From: Huber, Rachelle <RHuber@scsengineers.com>
Sent: Wednesday, September 2, 2026 7:10 PM
To: Nathaniel Dickel
Cc: Kevin Green; Bill Haley; Sarah Phillips; Dylan Smith; Jones, Art; Viswanathan, Srividhya; Sullivan, Pat; Bob Dick; Medina, Steven; Johnson, Cage; Travis Rohde; Baitong Chen; Larry Israel; Christina Ojeda
Subject: RE: Chiquita Canyon Landfill (Facility ID 119219) - Condition 63 Leachate Schematic
Attachments: 2026-09-02_CCLF Tank Farm Site Map(s) As-Built_v0.6.pdf

Please find the attached leachate schematic for your use.

4683 Chabot Drive, Suite 200

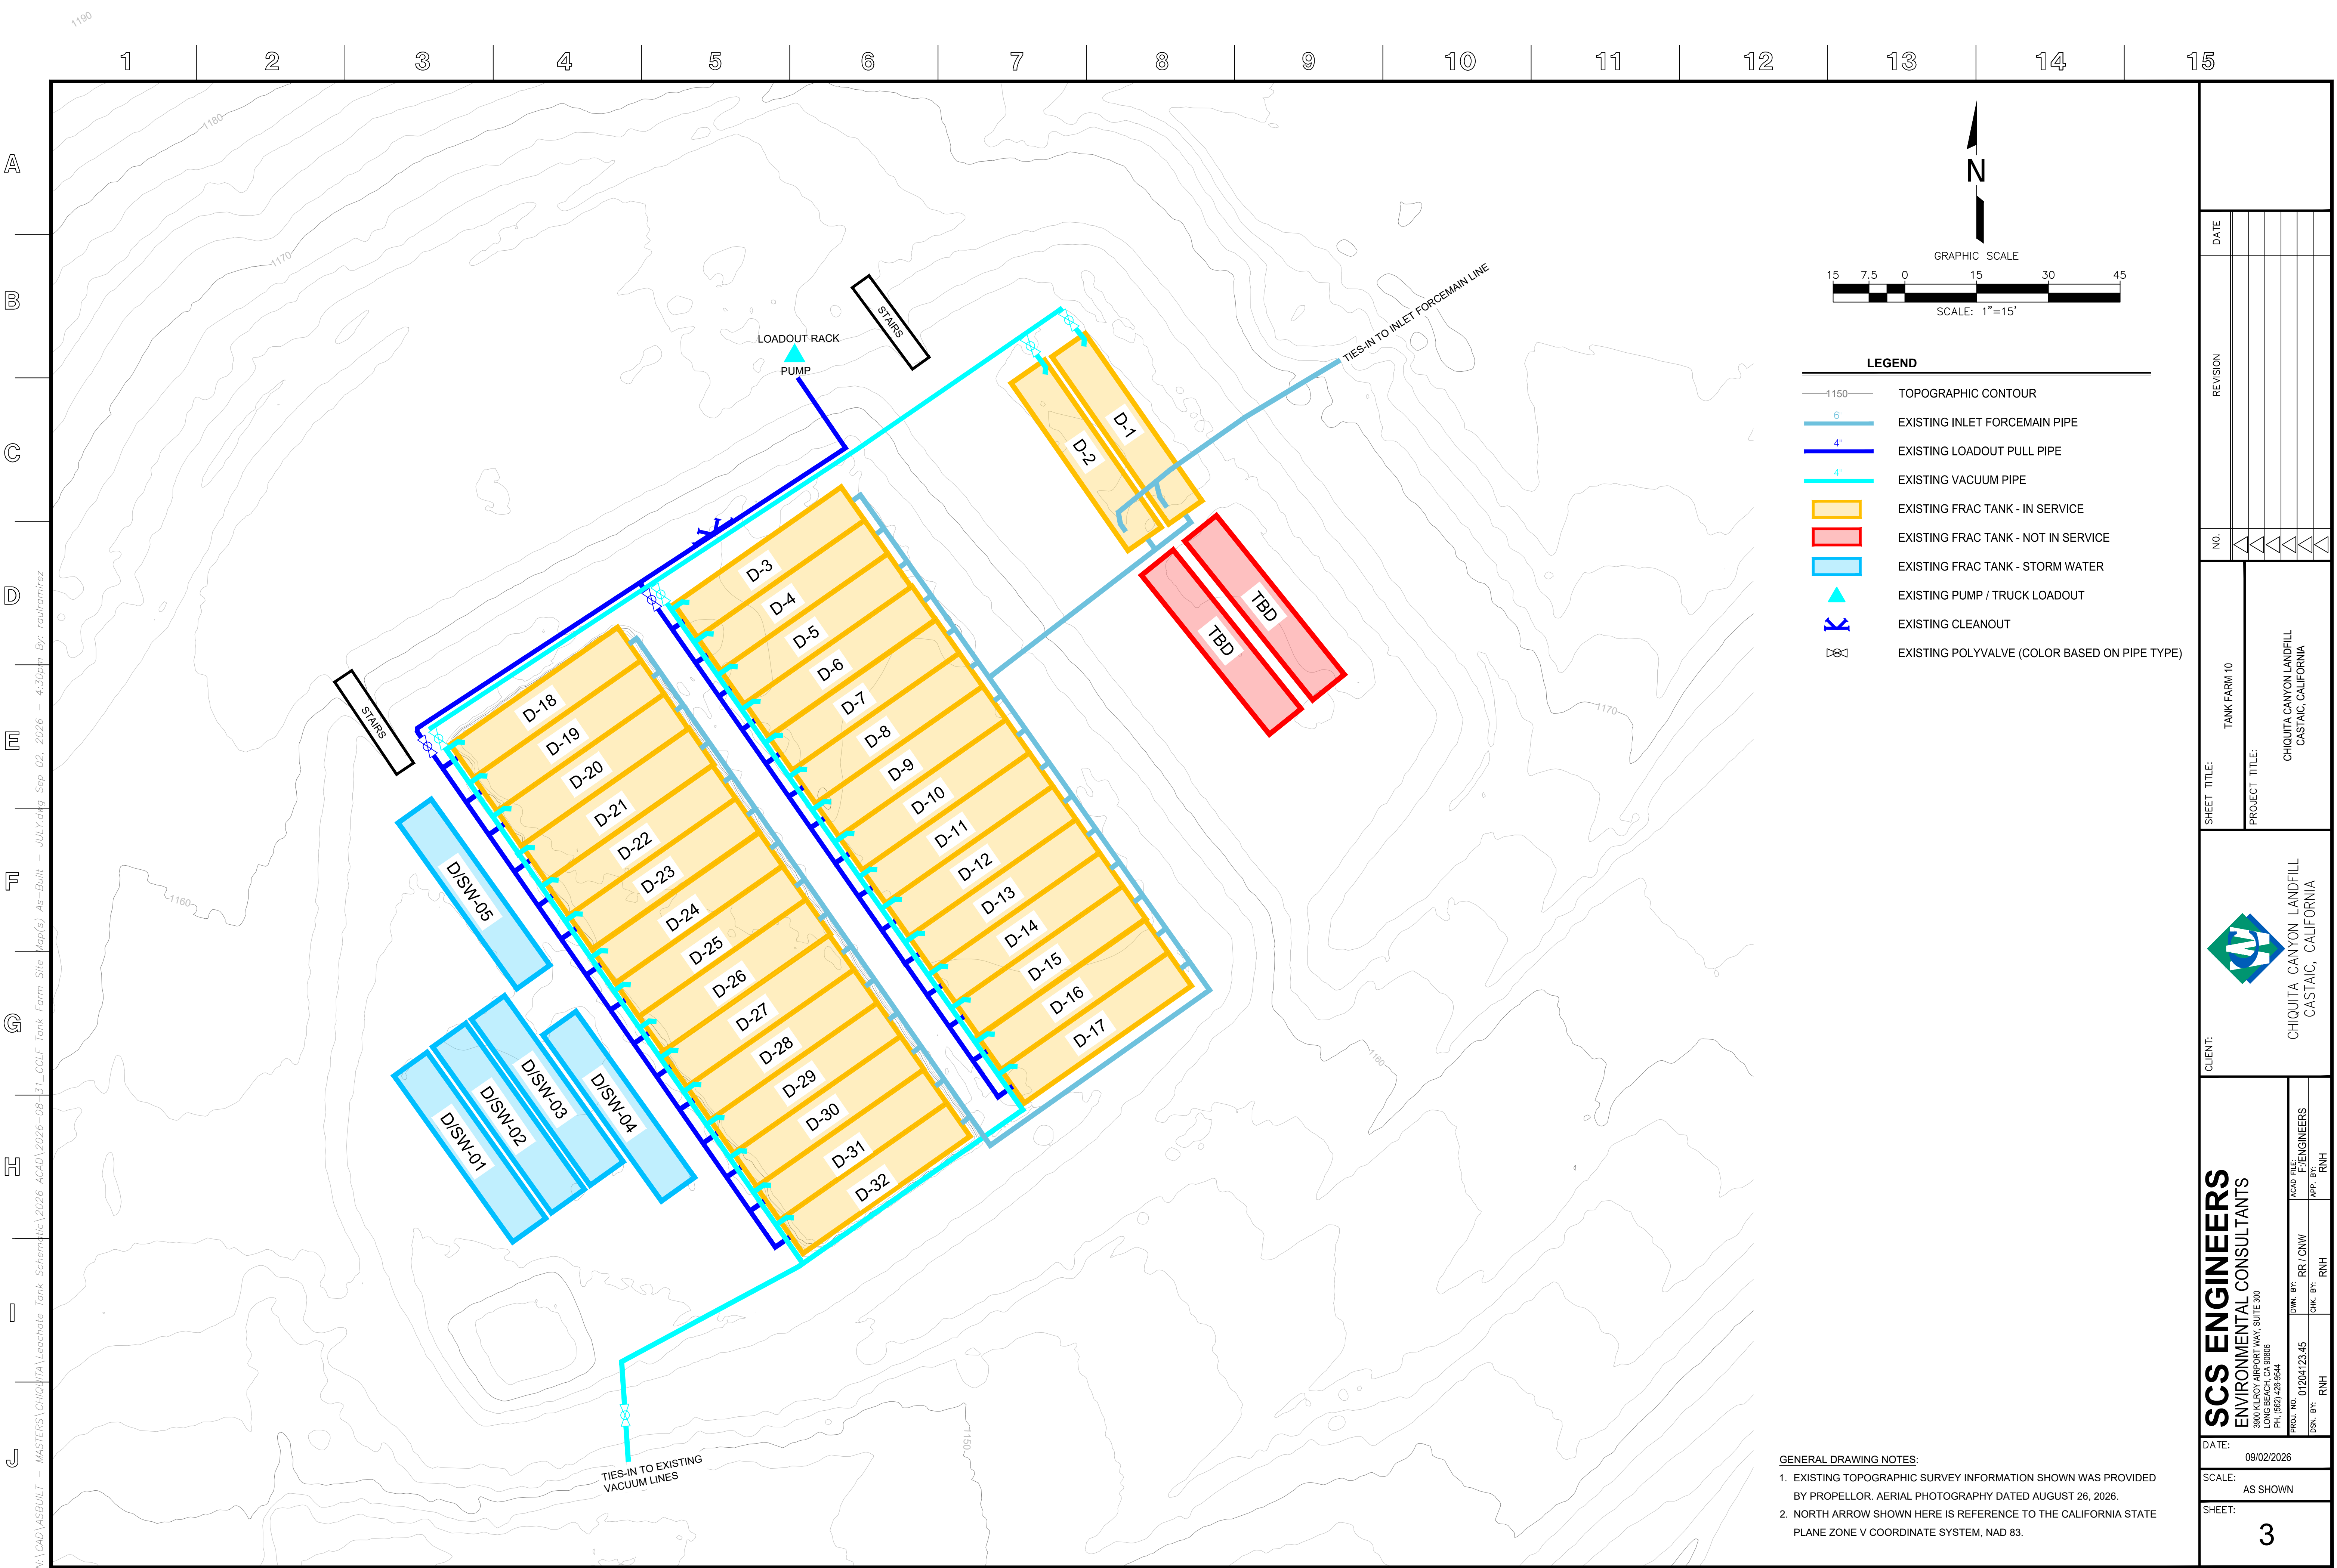
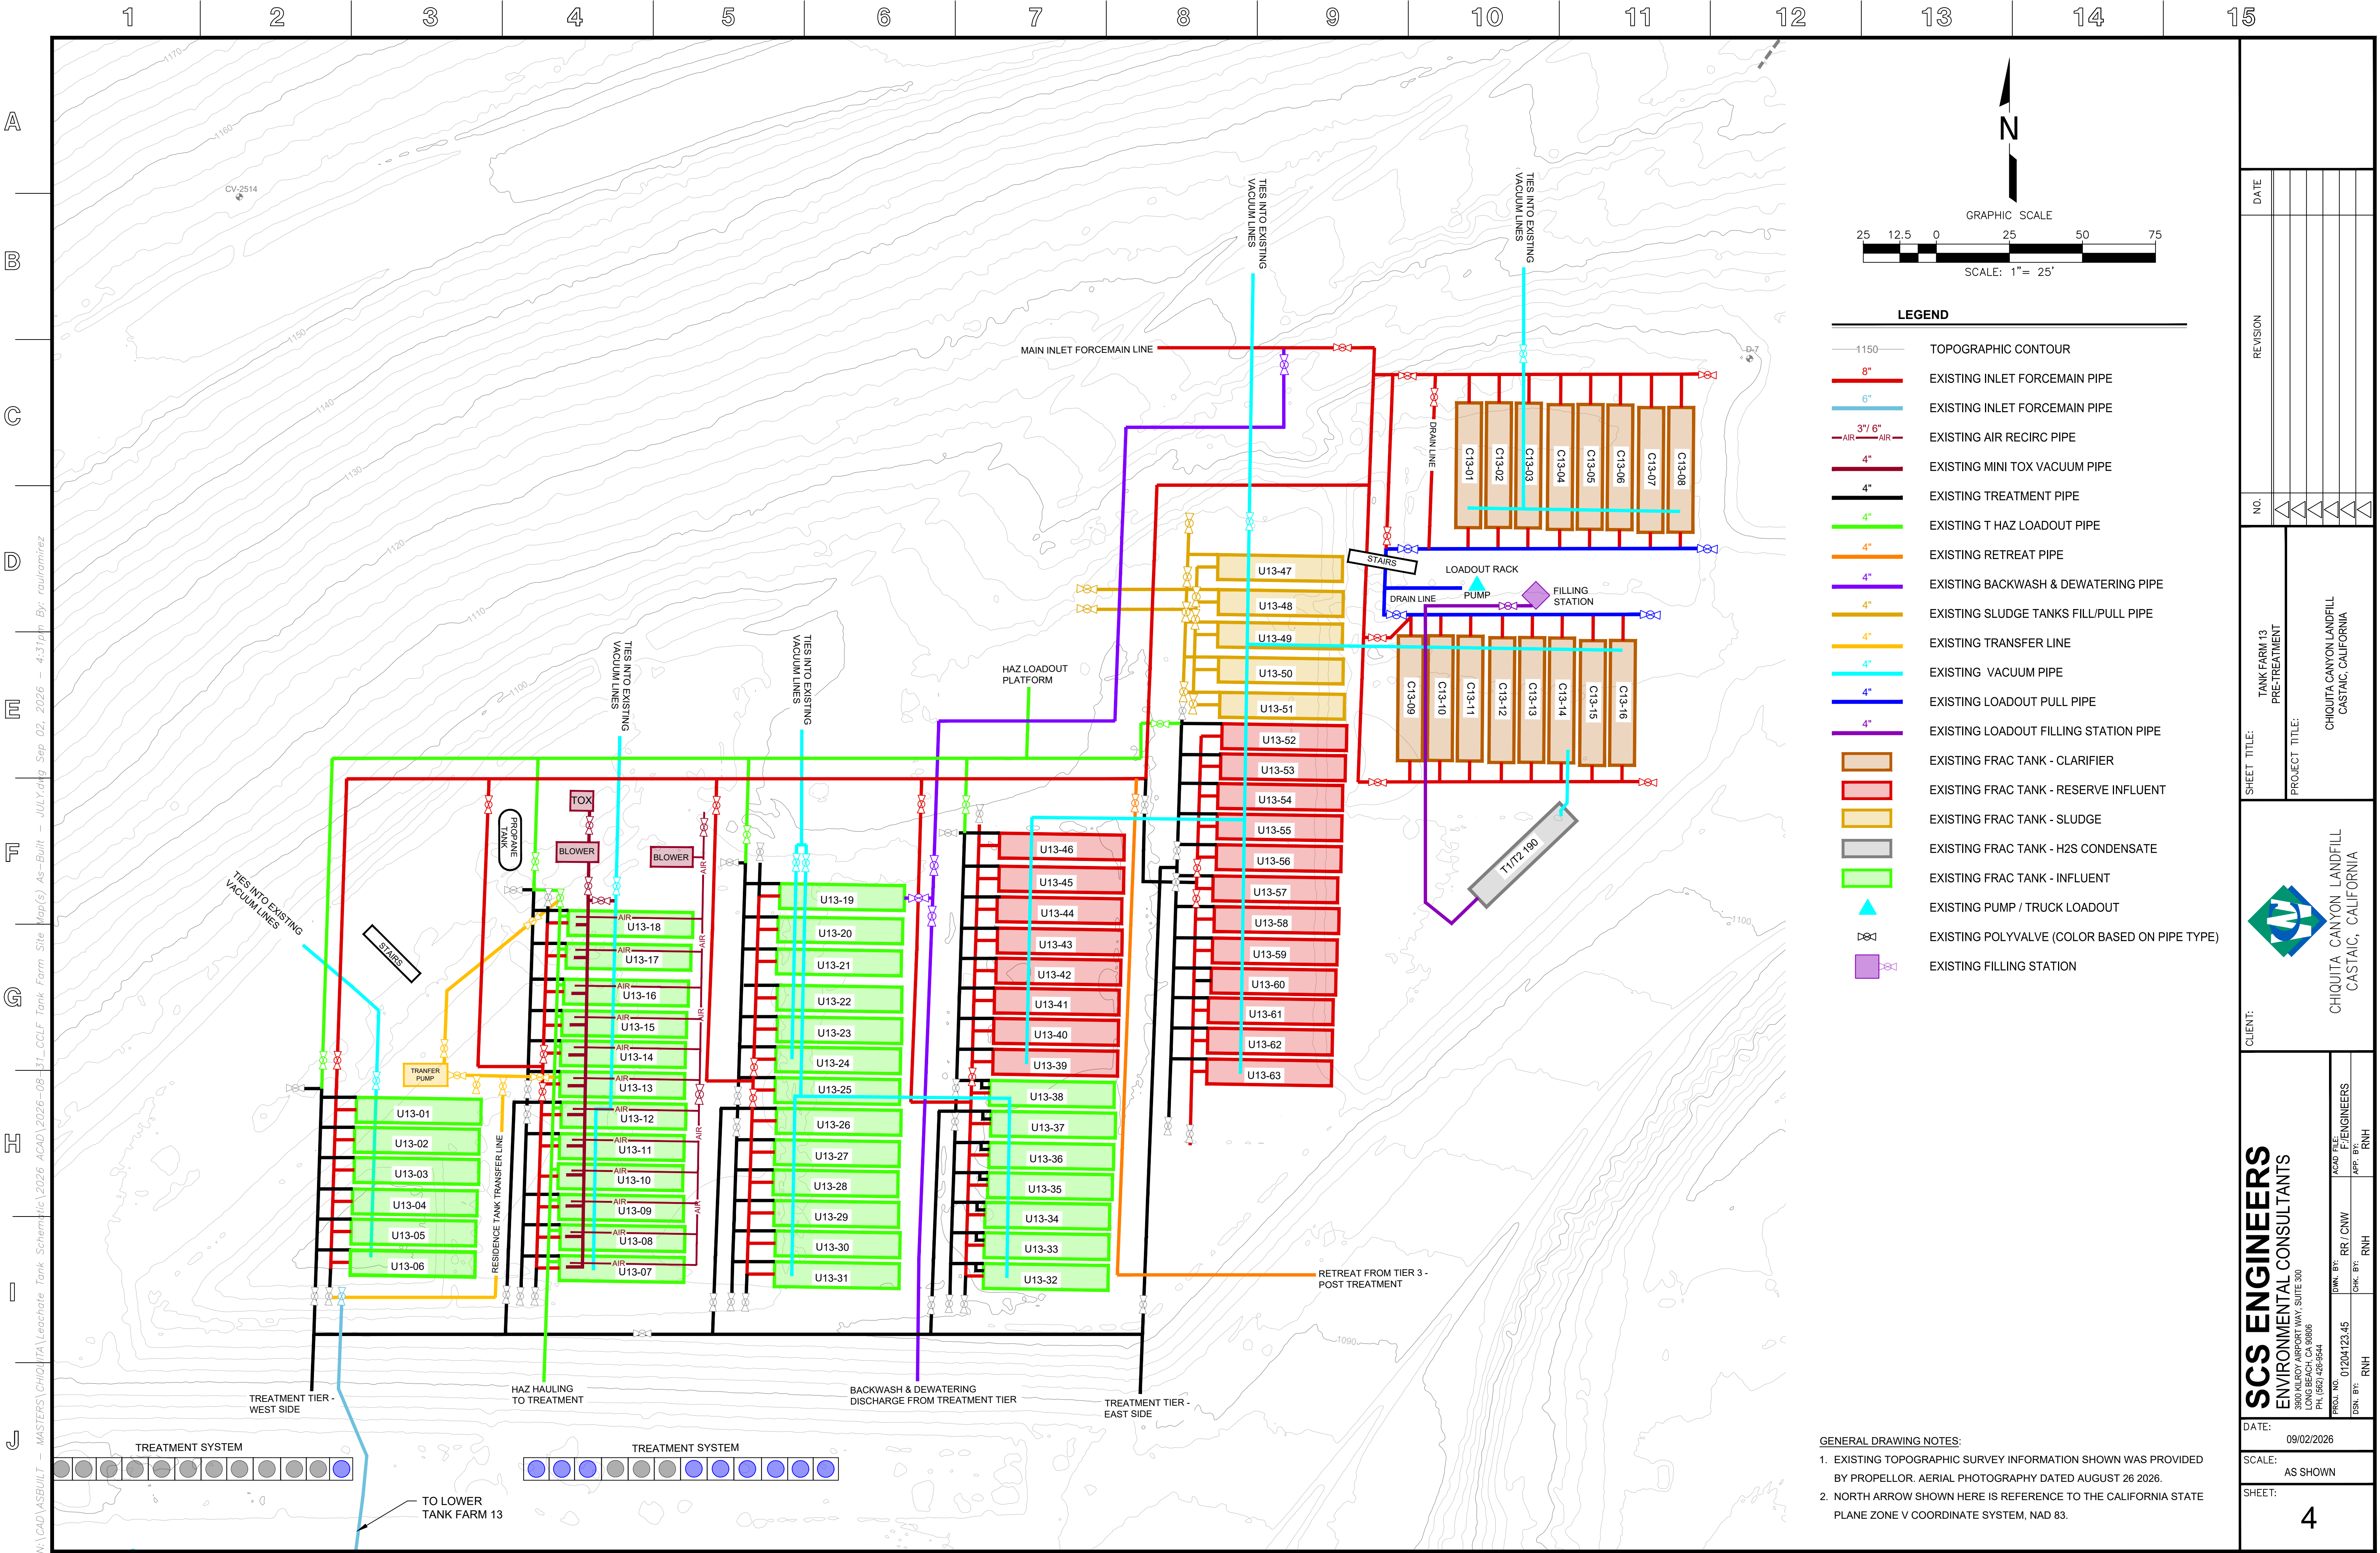
1. Tank Farm 10

- a. The provided as-built schematic does not mention any vacuum vent lines in the associated legend and does not show any vacuum vent lines on the schematic itself. Please confirm these tanks are vented to the gas collection system/control equipment and provide a revised schematic indicating the locations of the vent piping and valves.
 - ***Please find in the attached leachate schematic.***

2. Tank Farm 13 Pre-Treatment

- a. The provided as-built schematic and associated legend indicate there is vacuum piping only on the aeration treatment tanks (U13-13 through U13-18). There may be mislabeling in the legend, and miscoloring of certain piping within the tank farm. The cyan colored piping throughout the schematic is indicated to be drainpipe, inconsistent with the schematics for Tank Farm 7 and Tank Farm 13 Post-Treatment. Please review and provide a revised schematic for the Tank Farm 13 Pre-Treatment tanks.

- ***Please find in the attached leachate schematic.***
- b. Indicate whether tank T1/T2 190 is vented to control equipment, how liquid enters/exits the tank, and update the schematic as necessary with any vacuum and/or liquid piping. The current schematic shows the tank isolated without any connected vacuum piping, liquid piping, or loadout rack/pump.

- ***Condensate from the knockout pot at the flare station is directed through piping to either Tank T1 or Tank T2, both of which are located at the flare station. Condensate enters each tank through piping connected to the bottom of the tank. Each tank is also equipped with a vacuum line connected to the top of the tank that routes tank vapors to the flare station for control.***

- ***When the tank receiving condensate approaches capacity, Chiquita switches the condensate flow to the other tank. The condensate accumulated in the first tank is then removed by tanker truck and transported to Tank 190 in Tank Farm #13. Transfers from Tanks T1 and T2 to Tank 190 occur as needed based on the condensate level in Tank T1 or Tank T2.***

- ***Tank 190 is vented from the top of the tank and is connected to the same vacuum system that extracts vapors from the clarifier tanks at Tank Farm # 13. Condensate is transferred from the tanker truck into Tank 190 via an existing loadout filling***

station pipe through a 4-inch valve located at the bottom of the tank, and liquid exits Tank 190 through the same 4-inch valve at the bottom of the tank. The schematic is updated to show the applicable vacuum system, the existing loadout filling station pipe, and the 4-inch valve on Tank 190.
